SB: **Wall - mounted hose boxes**

Article : **8022, 8023, 8024, 8025**

Reason: **Improvement of the tightness**

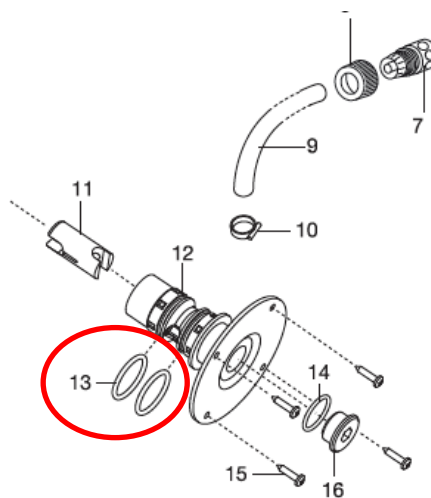
Solution: To avoid a leakage on the water pass (12) the o-ring 28,5x2,62 (13) will be replaced by a new one.
This new o-rings are implemented in the production with index J514 (8022) and B532 (8023, 8024, 8025) .

In cases of repairs we recommend to use only the new o-rings !

New spare part: O-Ring 29,5x2,7 08022-00.600.46
